This document contains suggested enhancements to the Advanced Library Format, using ALF 2.0 as baseline. The document serves as a worksheet rather than a formal proposal. The suggested enhancements are collected in no particular order. The idea is to keep track of evolving proposals here and then agree formally whether or not they should be part of the IEEE spec.

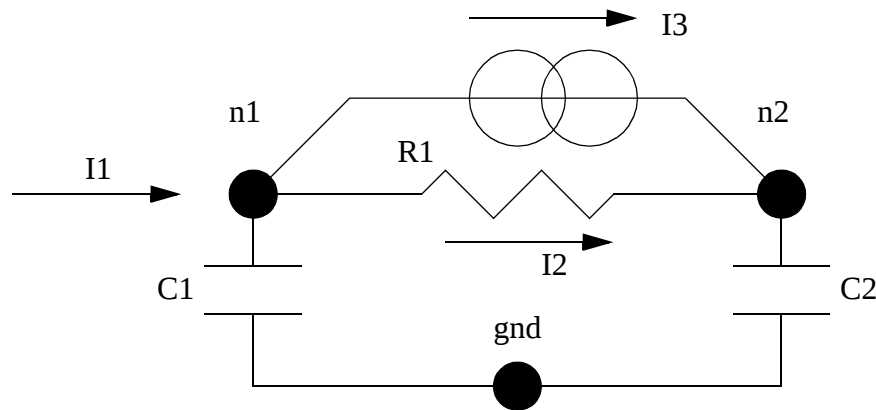
CURRENT needs PIN annotation indicating the target point where the current is flowing into. Cannot define a branch of an electrical network where the current flows through.

Therefore there will be 3 types of CURRENT specification:

- I1 = current into PIN from unspecified source (already supported in ALF 2.0)
- I2 = current through a COMPONENT with two terminal nodes
- I3 = current through an independent current source connected between two NODEs

see I1, I2, I3 in illustration

In the context of WIRE, the following mutually exclusive annotations for CURRENT shall be legal:

PIN = *pin_identifier* ;

Current flows from unknown source into the pin (already supported).

COMPONENT = *component_identifier* ;

Current flows through the component. The component must be a declared two-terminal electrical component in the context of the WIRE, i.e. a RESISTANCE, CAPACITANCE, VOLTAGE or INDUCTANCE (excluding mutual inductance, which has 4 terminals). The direction of the current flow is given by the order of node identifiers in the NODE annotation for that component (see ALF 2.0, chapter 8.15.3, 8.15.4).

```
NODE { 1st_node_identifier 2nd_node_identifier }
```

Current flows through a current source connected between the nodes. The direction of the current flow is given by the order of node identifiers in this NODE annotation.

```
WIRE interconnect_analysis_model_1 {  
    CAPACITANCE C1 { NODE { n1 gnd } }  
    CAPACITANCE C2 { NODE { n2 gnd } }  
    RESISTANCE R1 { NODE { n1 n2 } }  
    CURRENT I1 { PIN = n1; }  
    CURRENT I2 { COMPONENT = R1; }  
    CURRENT I3 { NODE { n1 n2 } }  
}
```

This example corresponds exactly to the illustration shown above.

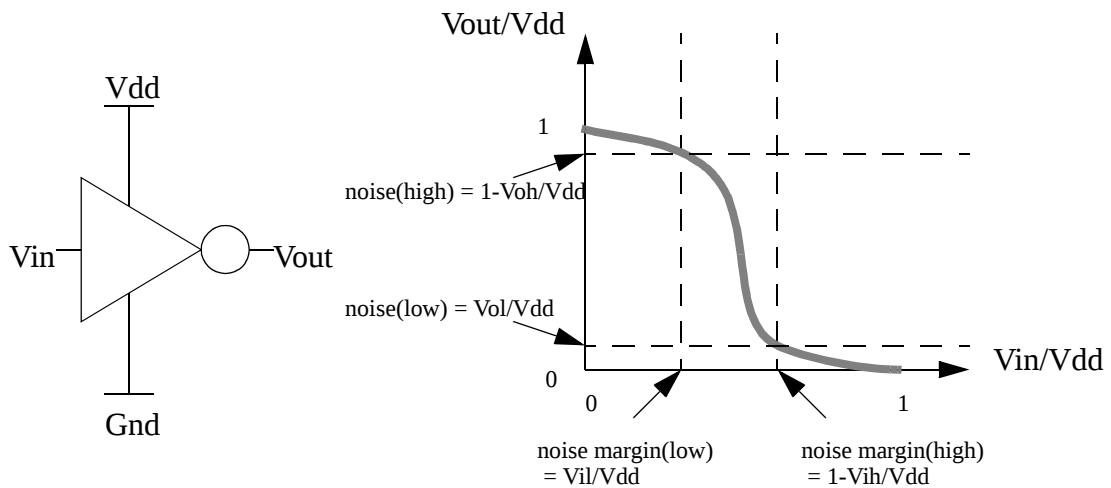
According to ALF 2.0, chapter 8.7.3, the sense of measurement for current associated with a pin shall be *into* the node. However, in some cases, the natural sense of measurement is *out of* the node. In order to allow explicit specification of the sense of measurement, the following feature is proposed:

FLOW annotation for current shall specify the sense of measurement of current. Default value shall be “in”, which is backward compatible with ALF 2.0.

This is illustrated in the picture below.

```
FLOW = in | out;
```

For example, the following two statements are equivalent:

```
CURRENT I1 = 3.0 { PIN = n1; FLOW = in; }
```

```
CURRENT I1 = -3.0 { PIN = n1; FLOW = out; }
```
